Tusuka Denim Ltd and Tusuka Washing Ltd

1 March 2015

Observations Building 1

Section at GL 9/H Foundation

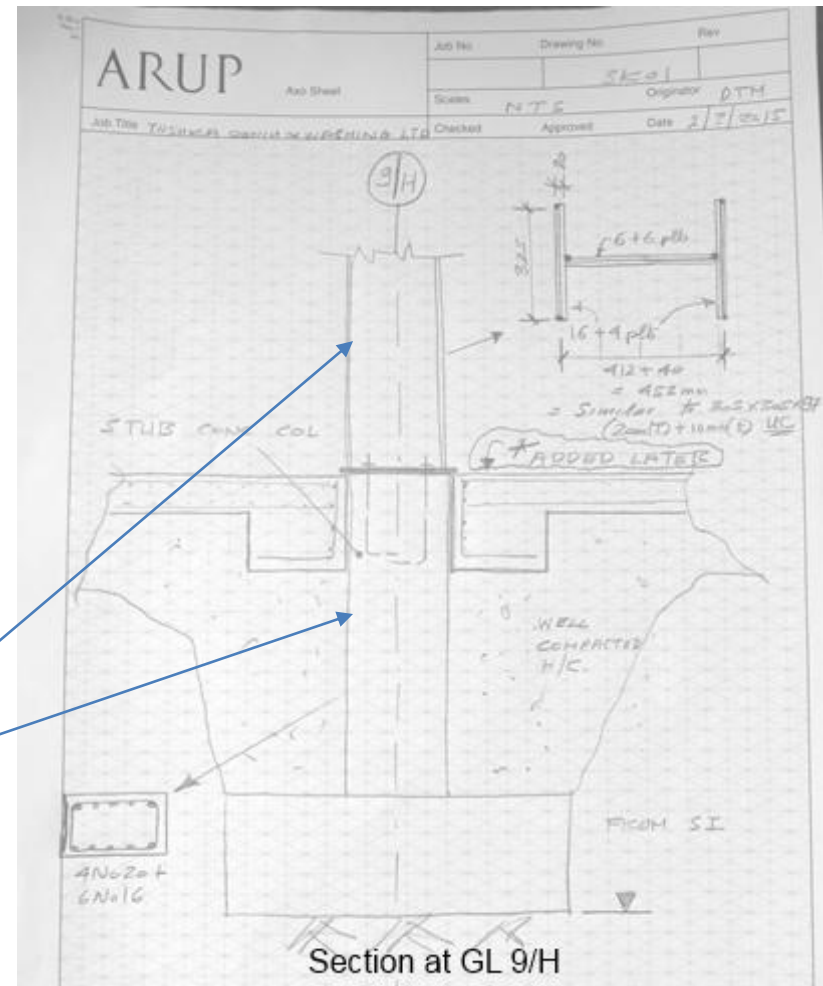
High Stress in Stub Columns

RC Stub column highly stressed when design loads specified in Table 1 are applied.

Item No.	Observation	Recommended Action Plan	Recommended Timeline
1	High Stress in Stub Columns	Factory Engineer to review design of stub columns for full loads noted in Table 1.	6-months
2	High Stress in Stub Columns	Carry out appropriate strengthening works as deemed necessary to meet code requirements for stub columns	6-months
3	High Stress in Stub Columns	Factory Engineer to prepare Allowable Loading Plans taking accounts of capacity of stub columns, allowable foundation pressure, steel columns and beams elements and of floor slabs.	6-months
4	Soils Report has low Allowable Bearing Pressure	Factory Engineer to review design of foundations at or near Bore Hole No 9 (9 Tons/sqm) shown in Soils Report.	6-months
5	Soils Report has low Allowable Bearing Pressure	Carry out appropriate strengthening works or load reduction as deemed necessary to meet allowable bearing pressure for foundations in this area	6-months

Soils Report – Bore hole 9

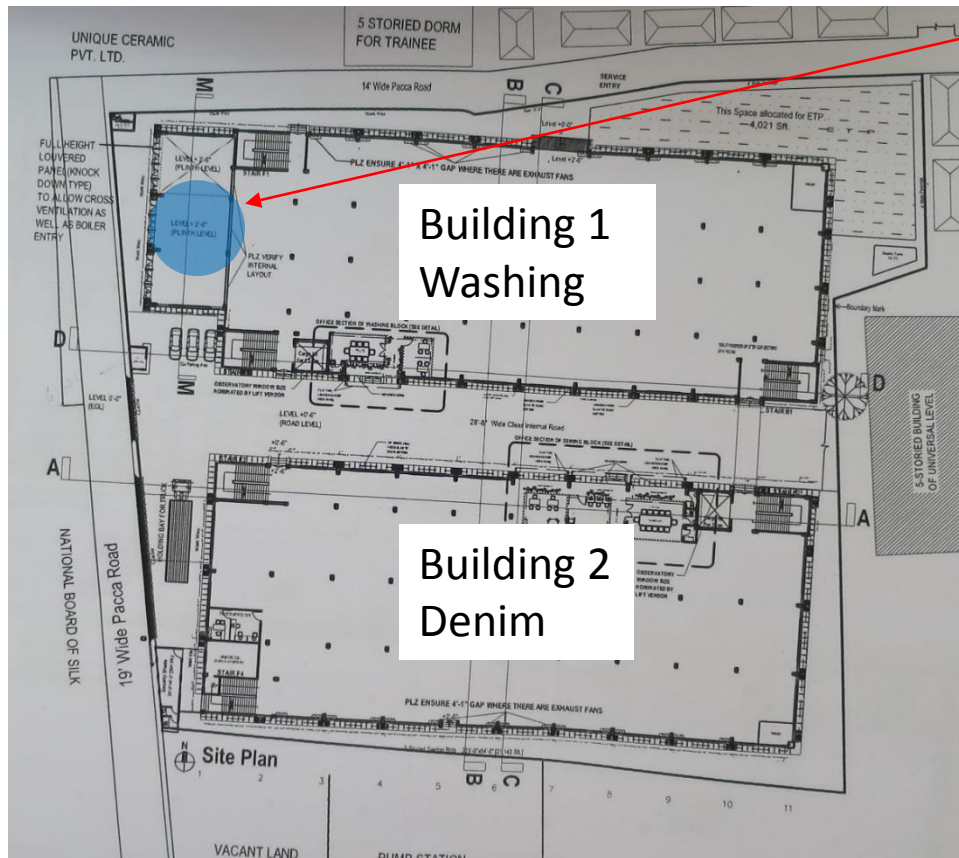
Soils Report has low Allowable Bearing Pressure

Soils Report has low Allowable Bearing Pressure

Typical Section

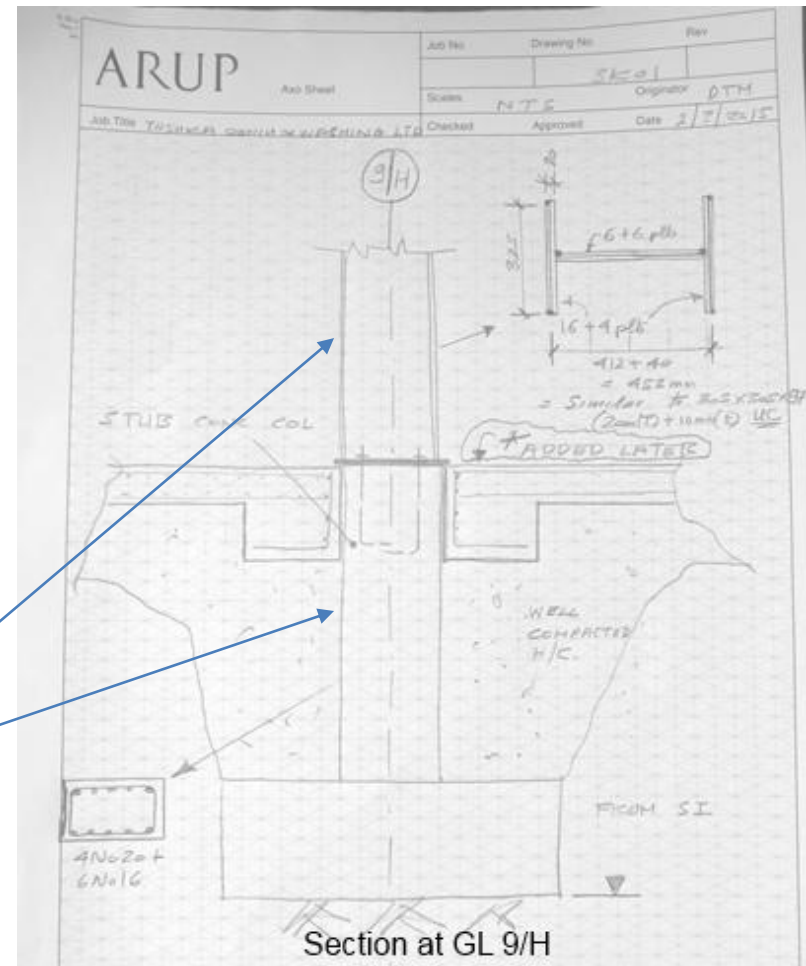
High Stress in Stub Columns

RC Stub column highly stressed when design loads specified in Table 1 are applied.
